## MEMORANDUM

To: Gord Closson, South Coast Standing Stem  
From: Iain Mill, Senior Naval Architect  
Prepared By: Shaun Wallis, Junior Marine Systems Engineer  
Date: 2019-04-08  
RE: **JB McCarron Barge Stabilization Refit Review**

J.B. MCCARRON BARGE  
STABILITY ASSESSMENT

Figure 1 - Hull void spaces. Note the submerged cylindrical tank attached to the aft end of the vessel.

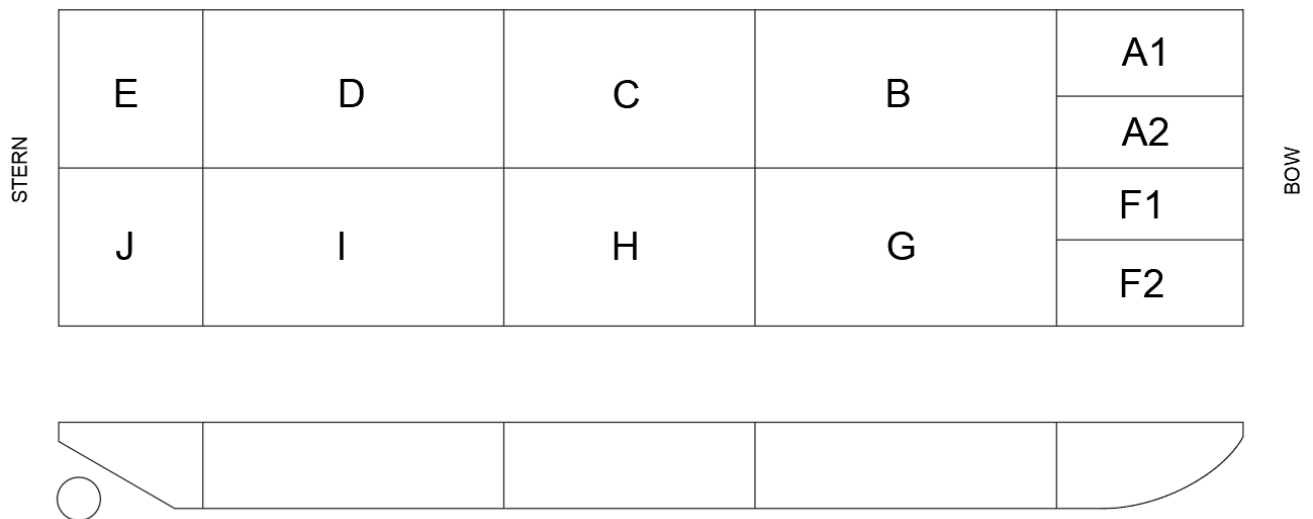
The void spaces in the vessel are arranged as shown in the following image

Voids B and G are each to be fitted with 130m<sup>3</sup> (4600 cu.ft) of closed cell foam with a density of 2lb per cu.ft. The foam is to be fitted from the bottom shell to the deckhead, and from 10 feet outboard (12 feet from the shell plate) to 20 feet outboard (2 feet from the shell plate). The foam is to be fitted to within 2 feet of the transverse bulkheads at either end of the space. The area where the fuel dump tank is installed does not need to be filled with foam.

Voids C and H are each to be fitted with 190m<sup>3</sup> (6700 cu.ft) of closed cell foam with a density of 2lb per cu.ft. The foam is to be fitted from the bottom shell to the deckhead, and to 2 feet from the bulkheads and shell plate in each direction.
